Westinghouse
Electric Corporation

DCP/NRC1003
NSD-NRC-97-5289
Docket No.: 52-003

SUBJECT: AP600 RESPONSE TO REQUESTS FOR ADDITIONAL INFORMATION

Enclosed are the Westinghouse responses to NRC requests for additional information related to WCAP-14407, "WGOthic Application to AP600." Responses are provided for the items listed in the attached table. These RAI responses are the second group of RAIs related to information contained in WCAP-14407, Rev. 1, and include the RAI responses related to 2-D conduction which were scheduled to be completed on 8/31/97. The first group of RAI responses related to WCAP-14407, Revision 1 was sent to you via Reference 1.

Figure 480.636-1 - Pressure Comparison

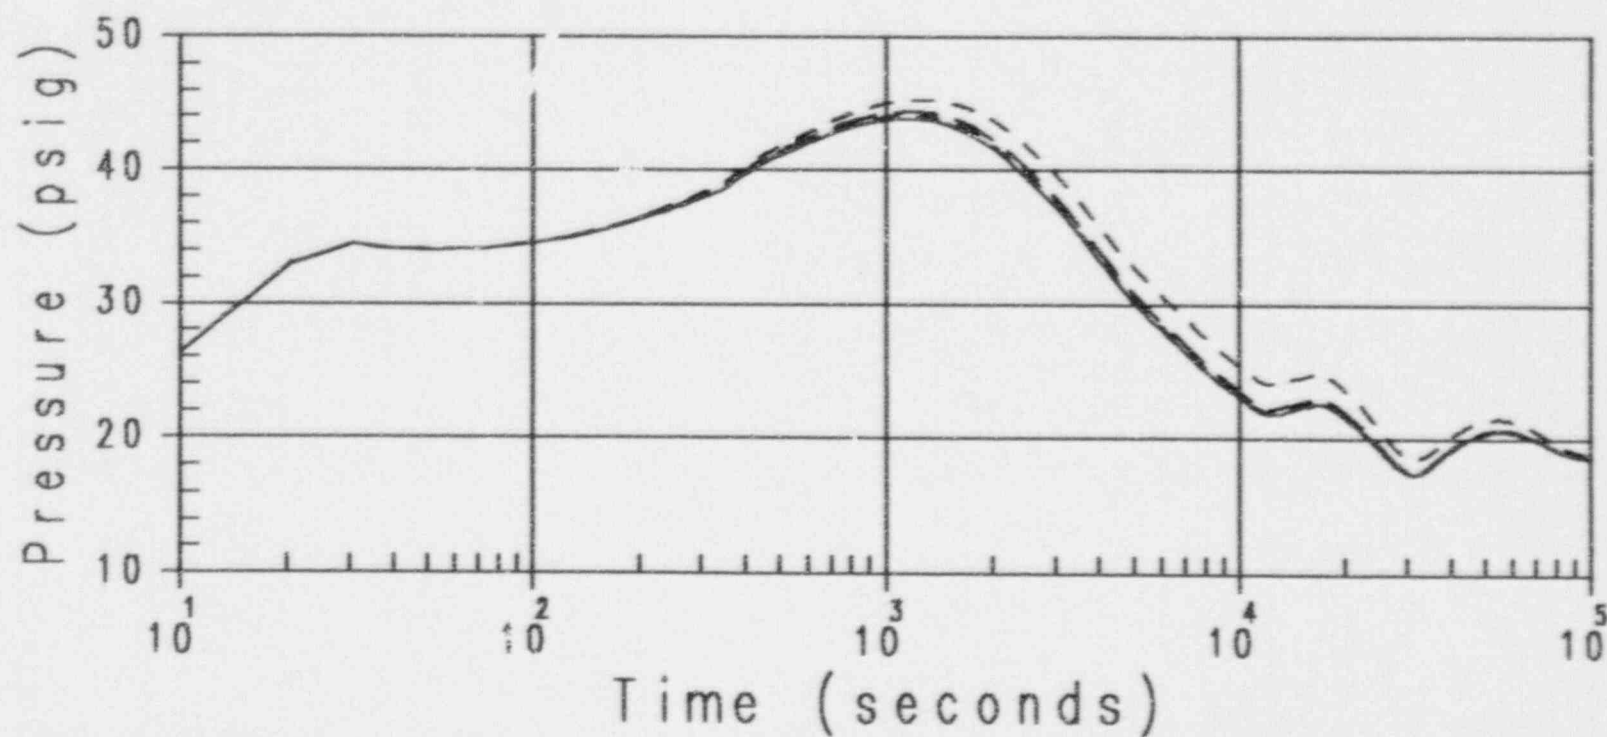
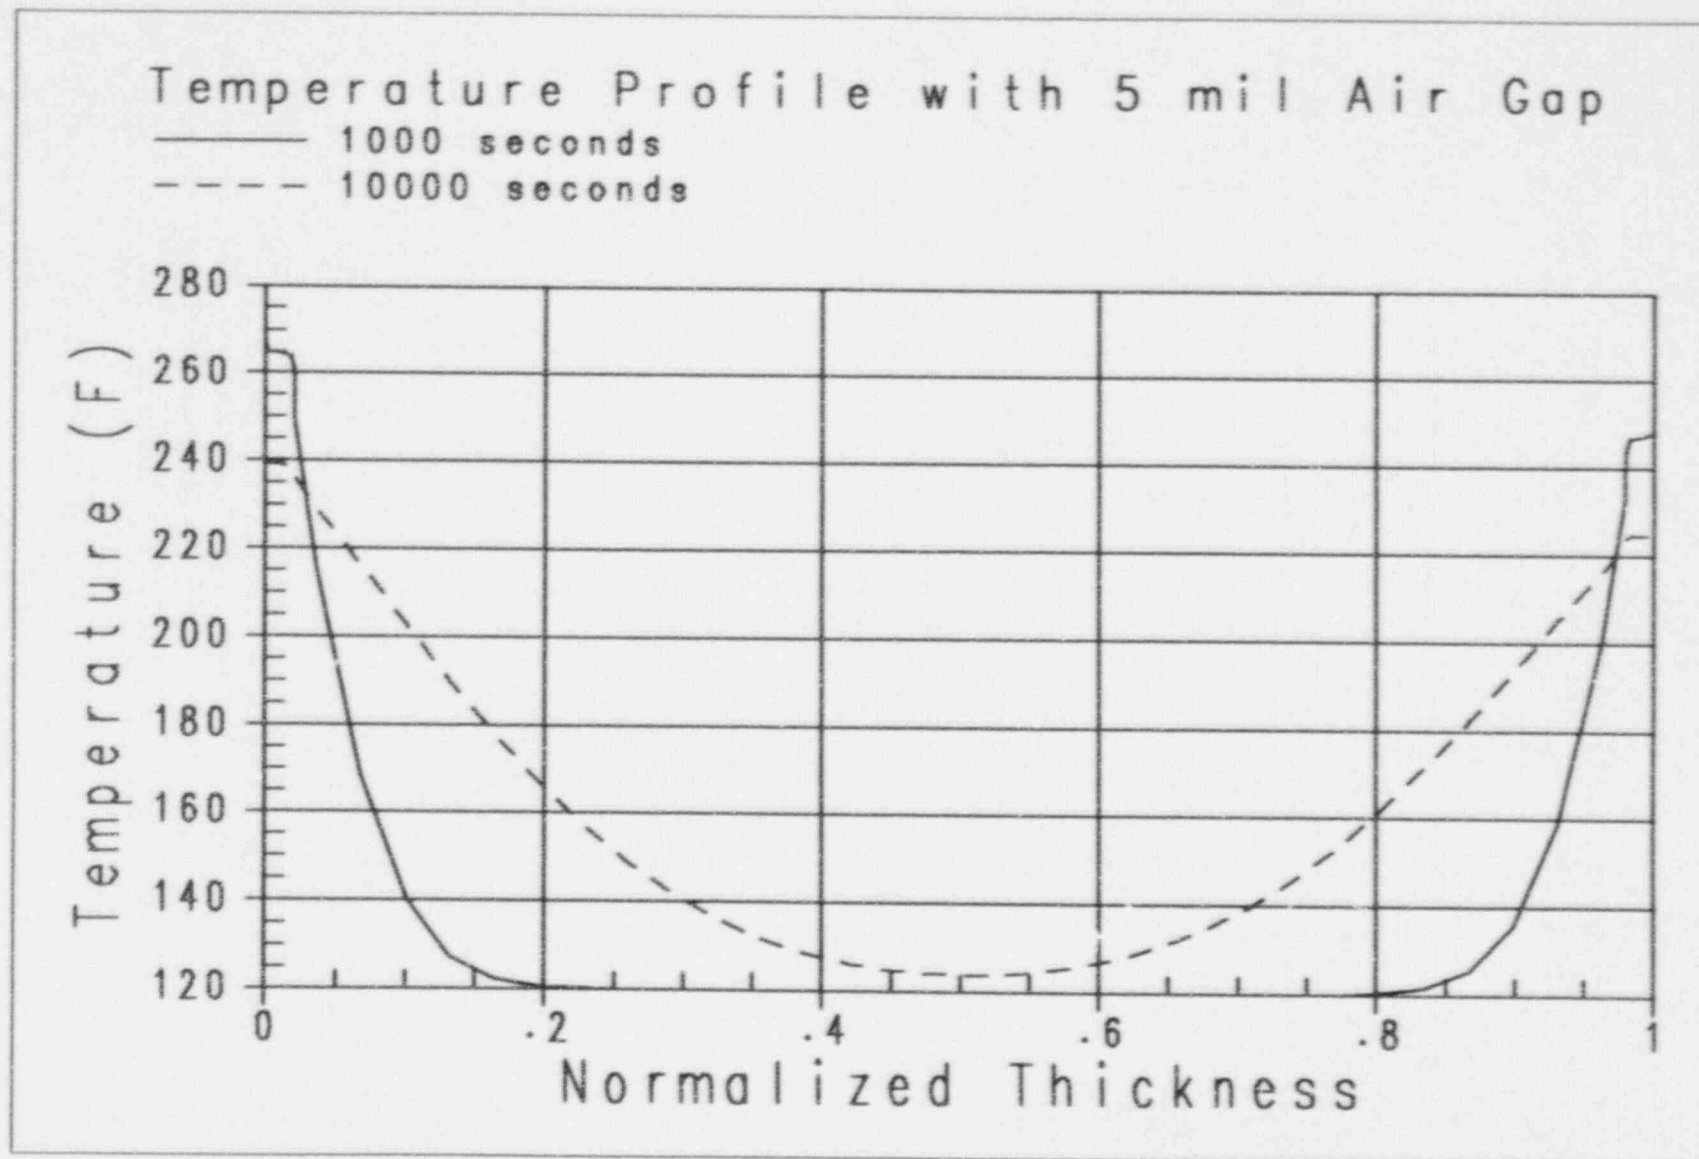
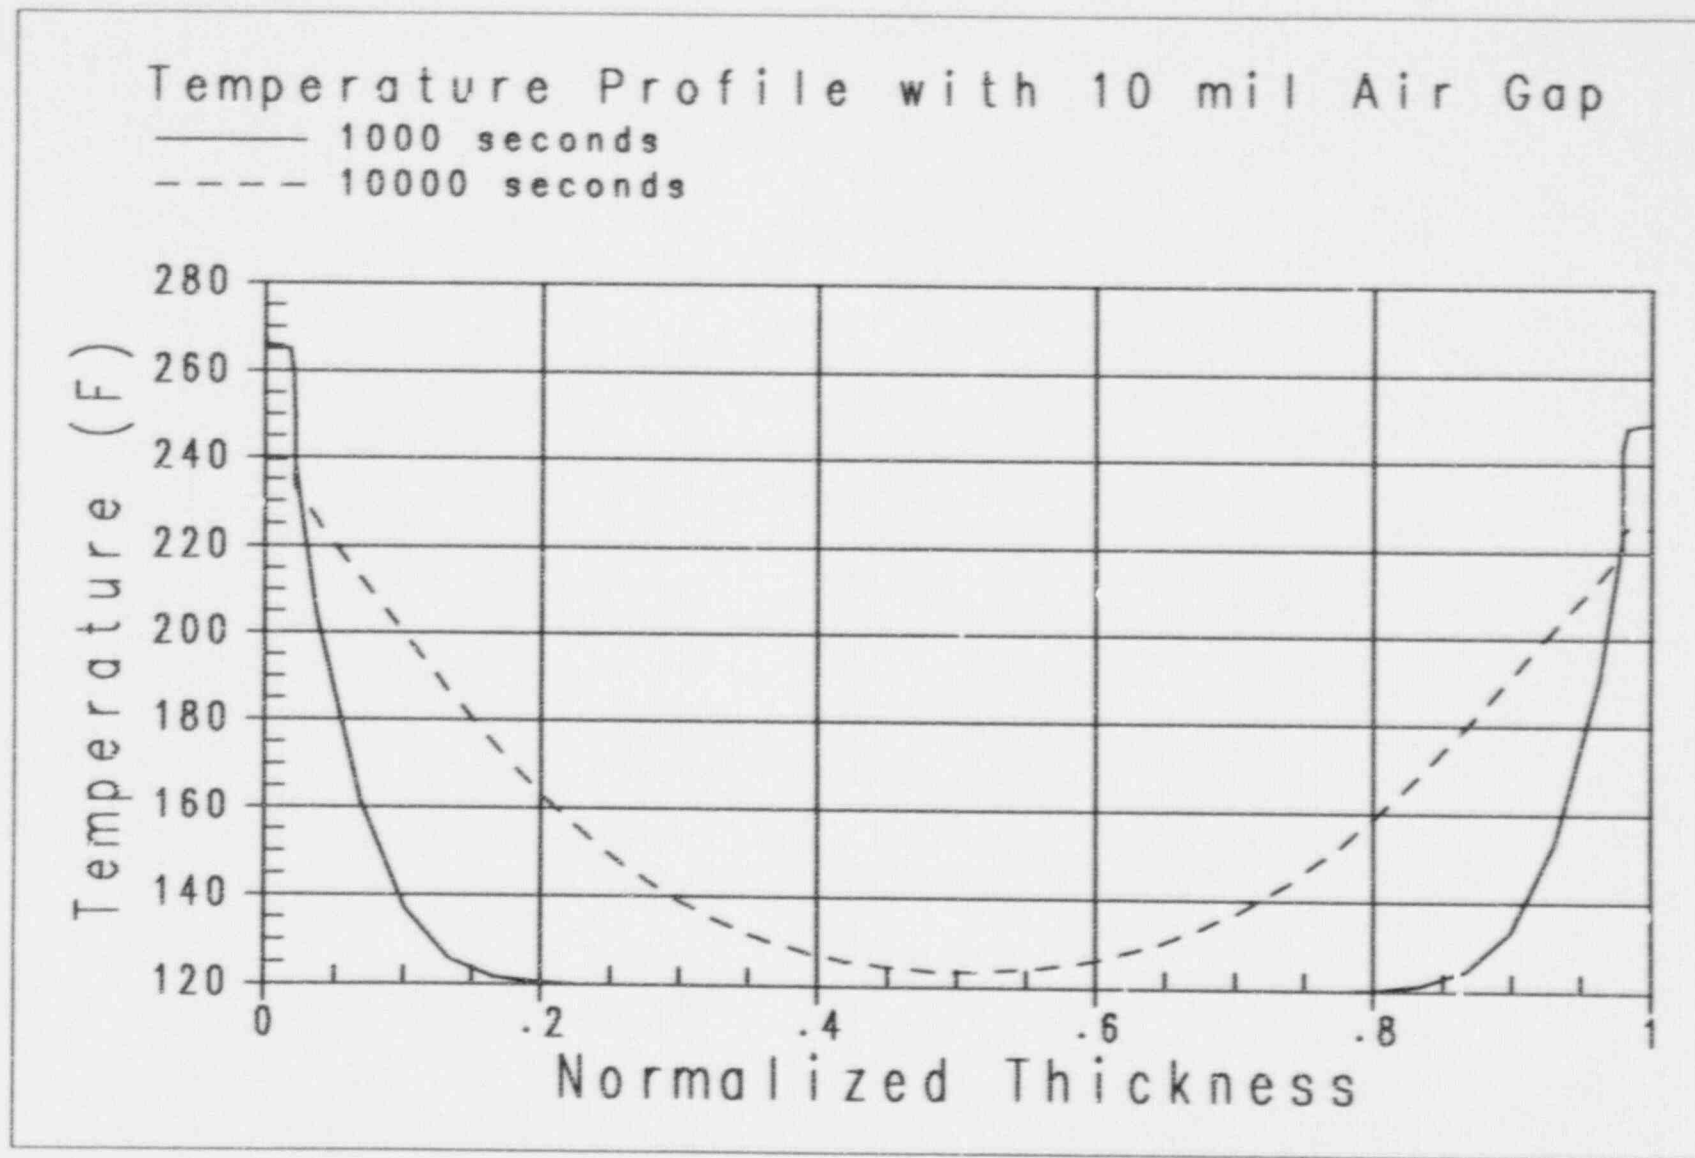
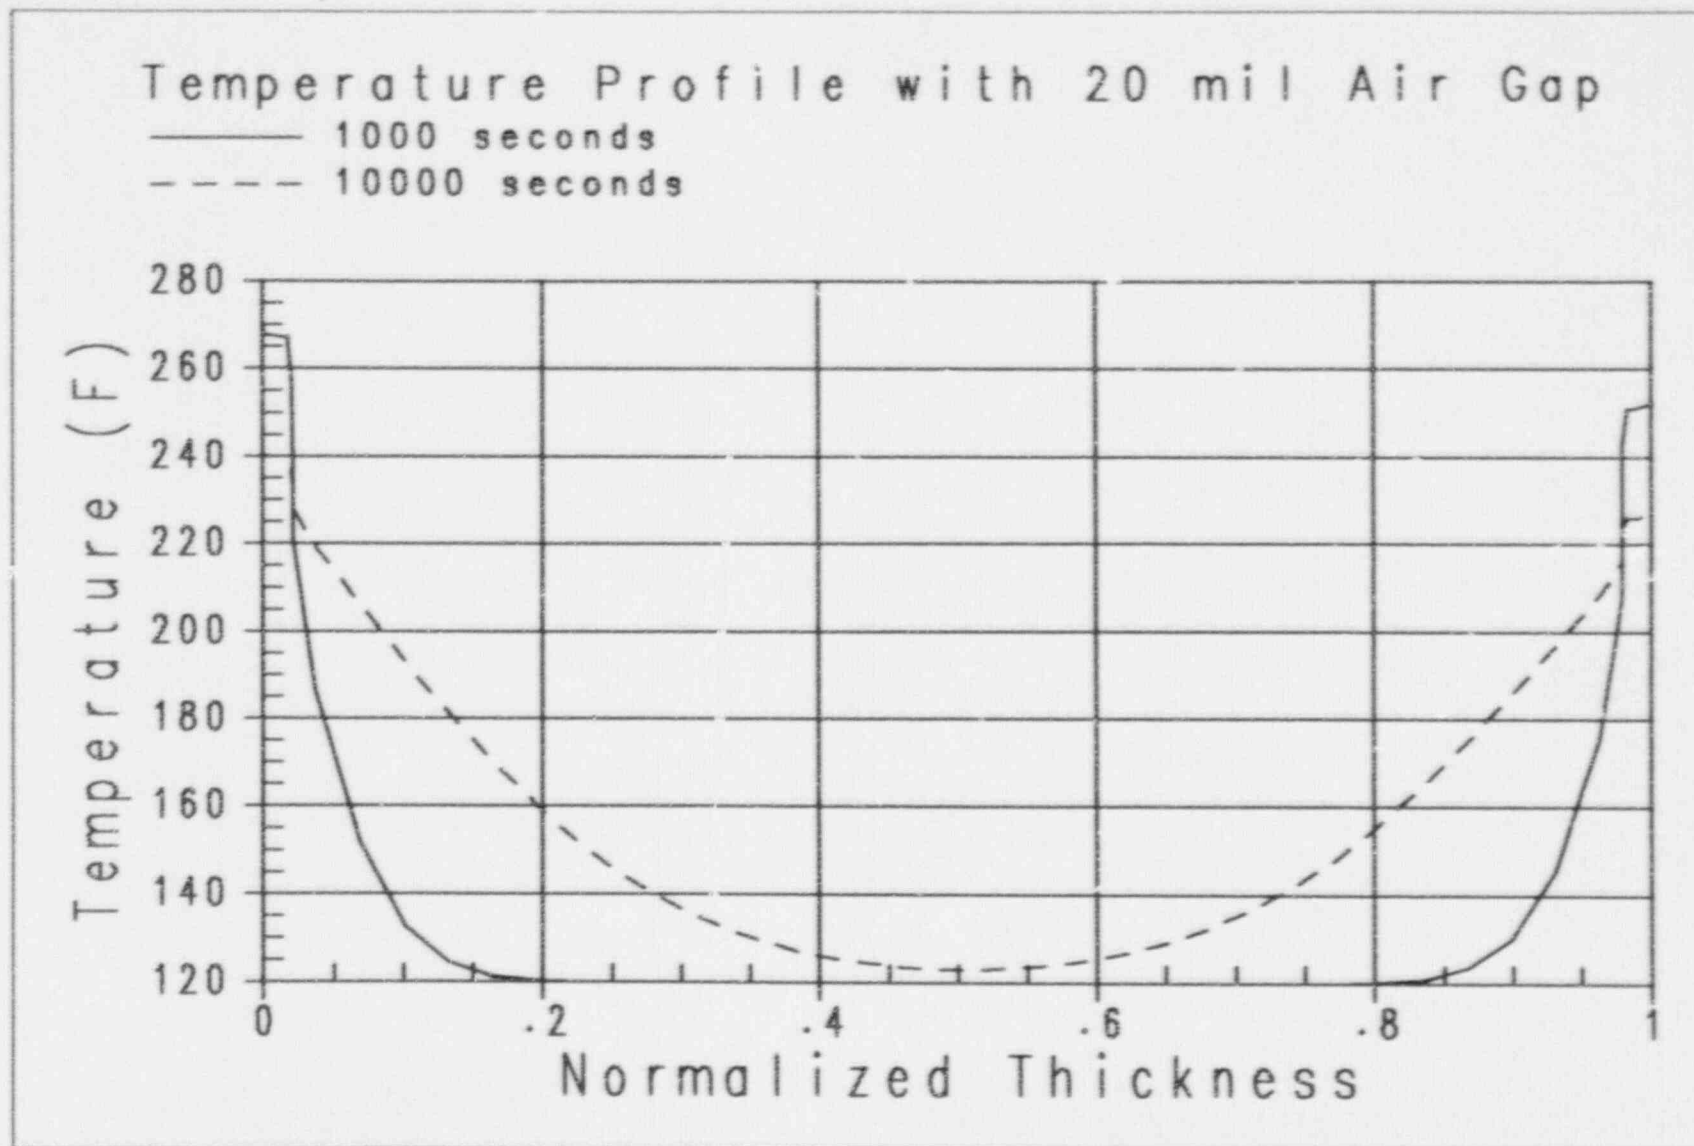
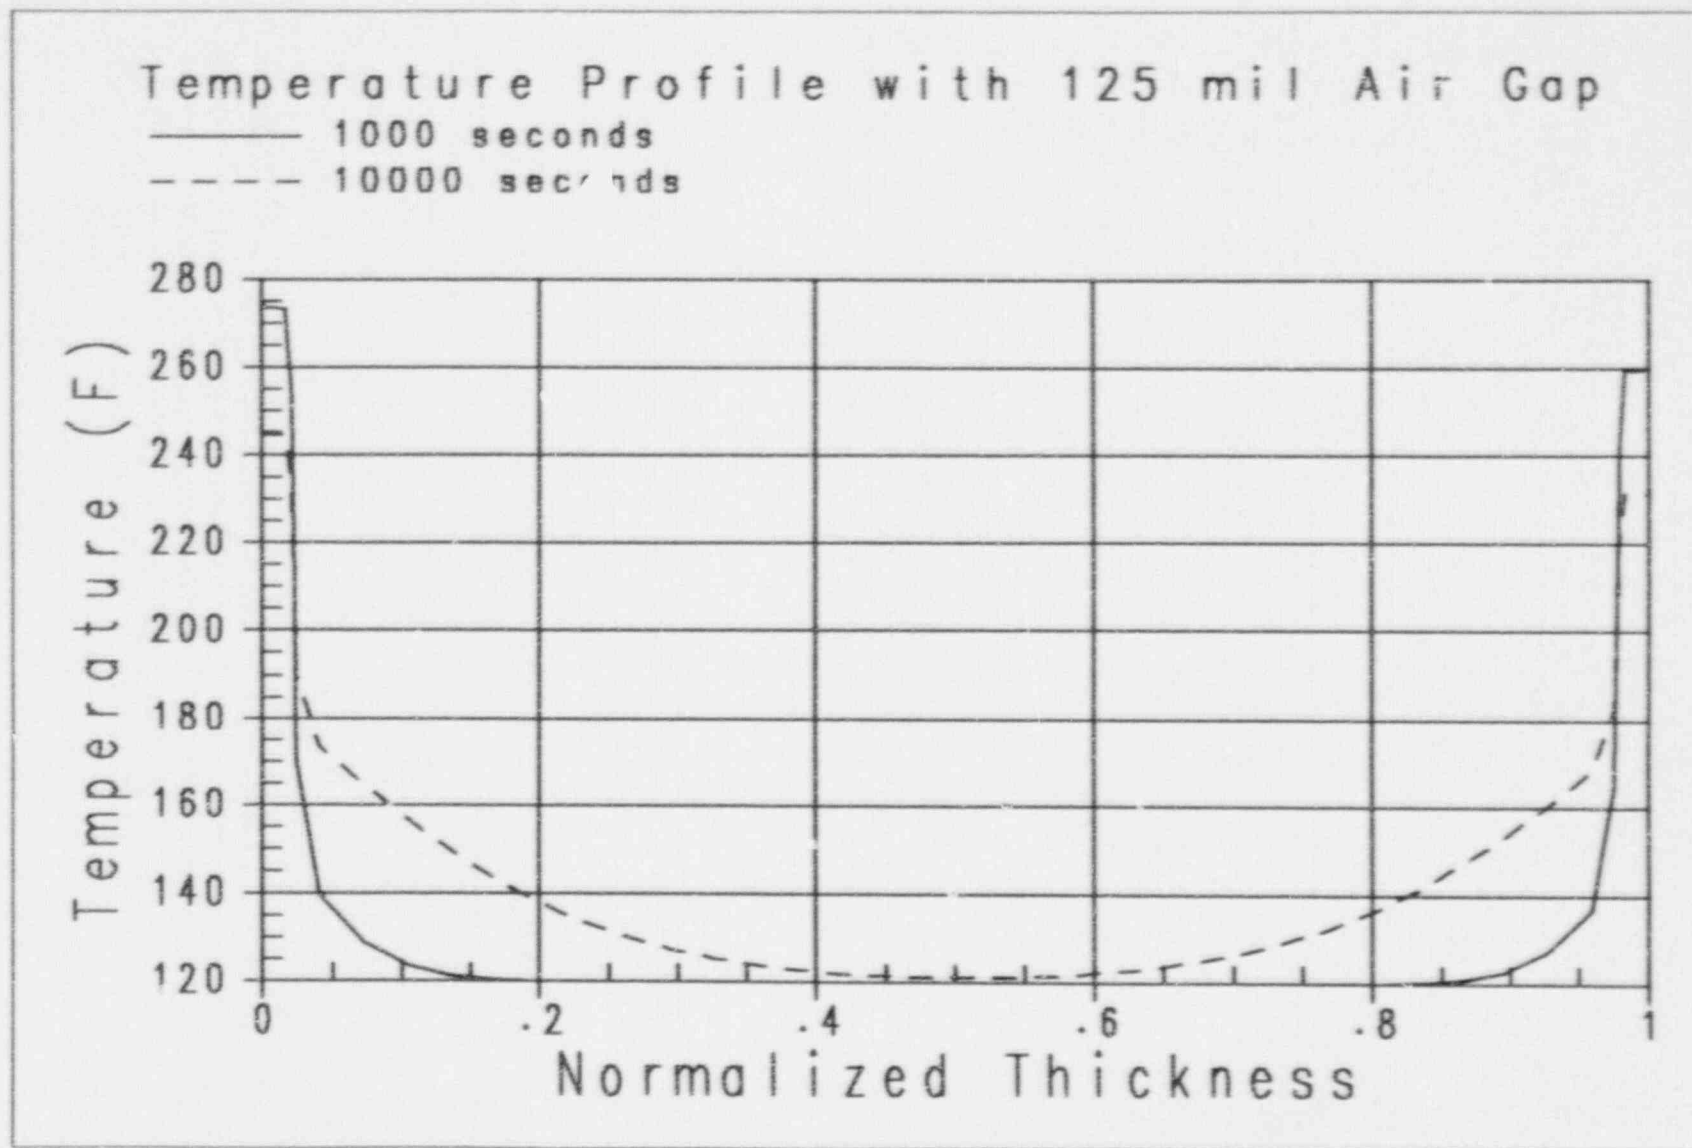
Section 5 of WCAP-14407 presents a sensitivity study on initial conditions. WCAP-14407, Subsection 5.9 (p. 5-11) presents the effect of changes in the steel jacket-to-concrete air gap thickness, results of which are displayed in Figures 5-7 and 5-8. The following questions arise from the information presented.

The peak pressure response comparison with the reference model is shown in Figure 480.636-1; the peak pressure for each case is given in the table below.

Figure 480.725-1 IRWST Vents

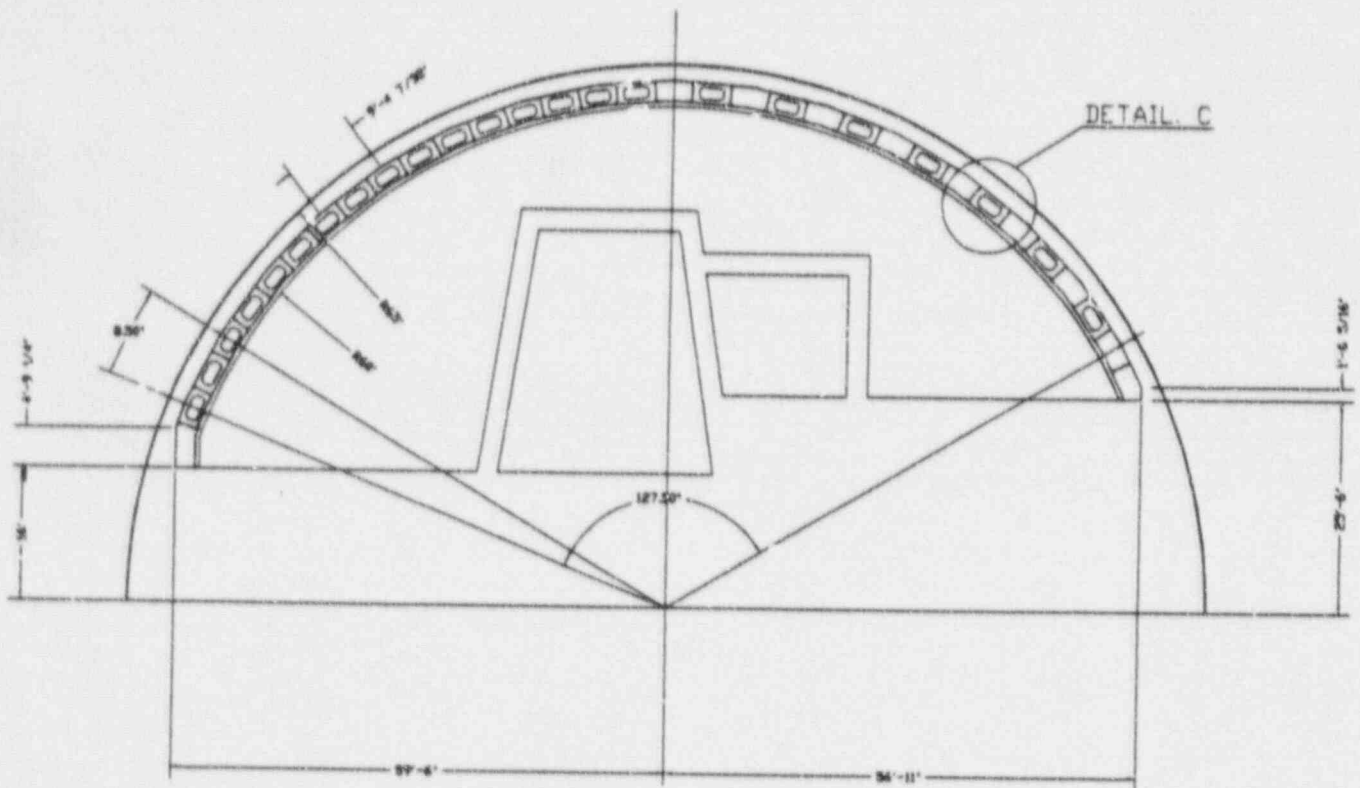
Provide a figure which shows the circumferential vent layout connections from the in-containment refueling water storage tank (IRWST) to the outer quarter annuli.

The circumferential vent layout from the IRWST to the outer annuli is shown in Figure 480.725-1. These vents are modeled as WGOTHIC model flow paths 17, 18, and 19. The combined flow area of these paths is modeled as 95.03 ft².
